DEVIATION REVIEW AND DECISION FORM

Deviation No. 2
REV. 2-8-19

Subdivision or Project Name: Rollin' Ridge Estates

Specific Criteria from Which a Deviation is Sought: Table 2-5 - Intersection spacing along a Rural Minor Arterial.

Deviation Exhibit

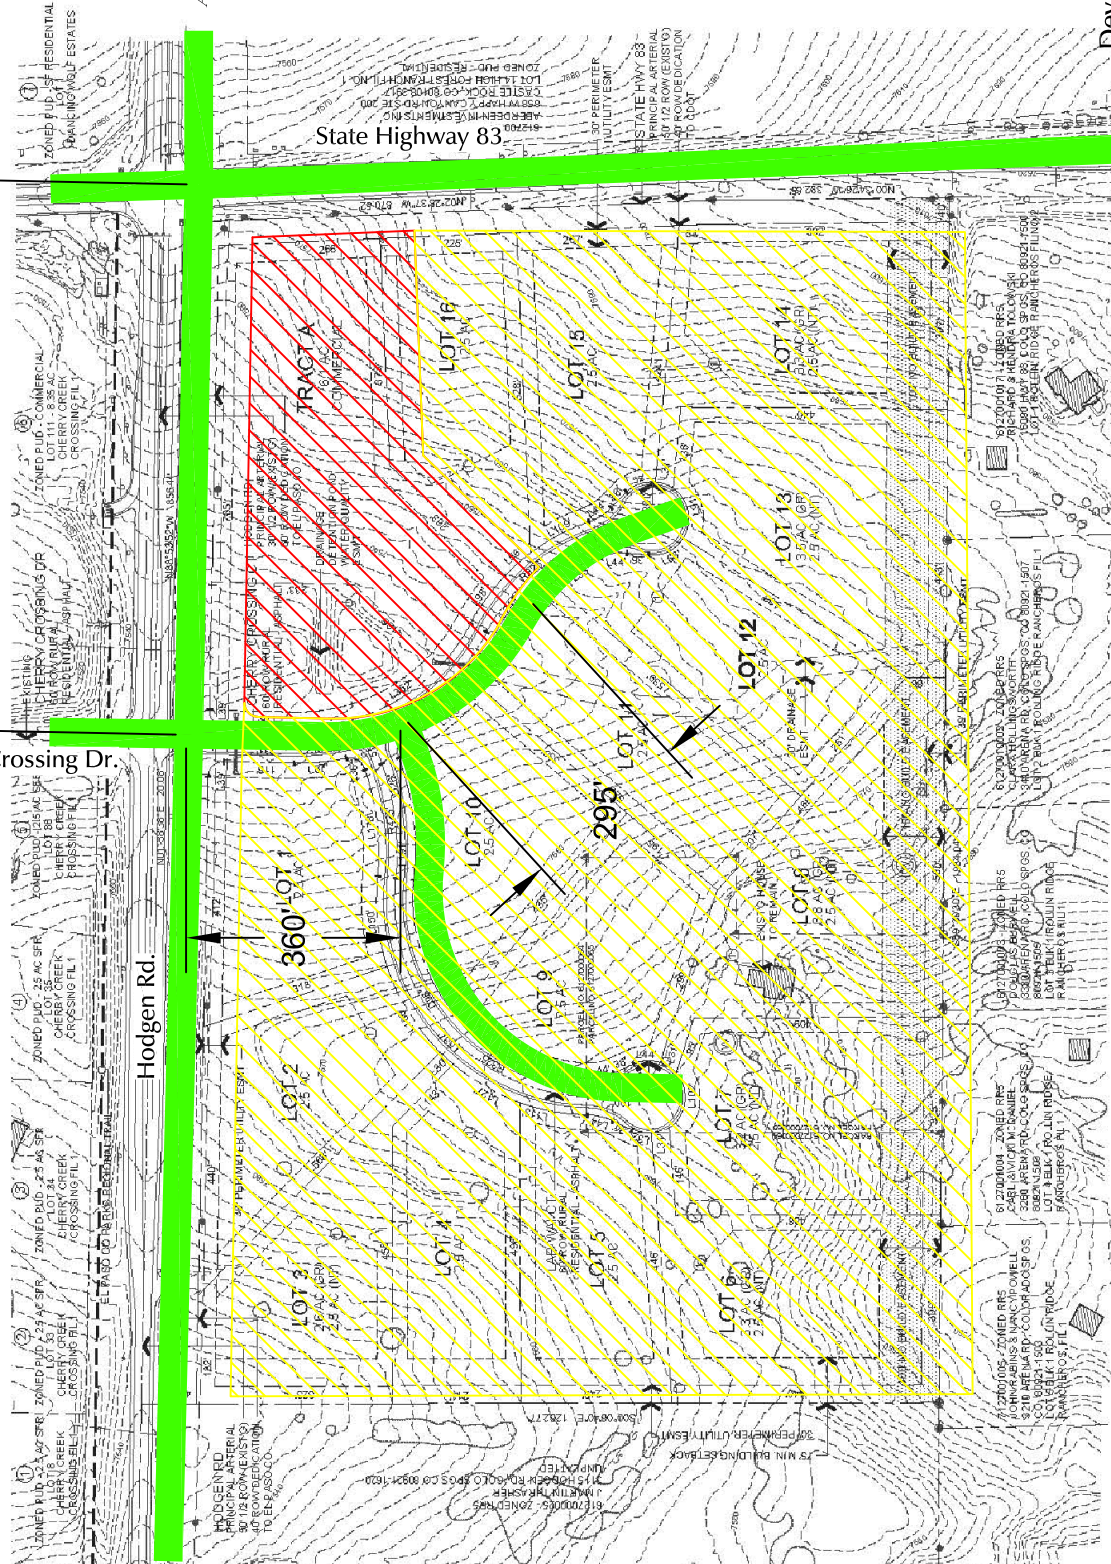
This deviation and deviation 1 have the same request, intersection spacing on Cherry Crossing between Hodgen and Prayer Tree Trail. Please remove the intersection spacing request from deviation 1 (ie, do not ask twice). Please clean up all exhibits (for ALL deviations), removing all unnecessary exhibits for the given deviation and marking/highlighting the area of concern consistent with the request for each specific deviation. Private driveways for commercial sites have different requirements, per road classification, than street intersections. Please adjust your deviation request to state that you are adding the two commercial accesses where none are allowed per table 2-4 of the ECM (not that your spacing is not to ECM standards). A deviation for the spacing of the intersections (Hodgen and Prayer Tree Trail) is also required.

In general, this deviation request is for intersection spacing but you reference the 'commercial access'. It should reference an intersection (not a commercial access) when requesting a deviation for "INTERSECTION" spacing. Again, this deviation should request two things, intersection spacing and the addition of two commercial accesses onto a Minor Arterial.
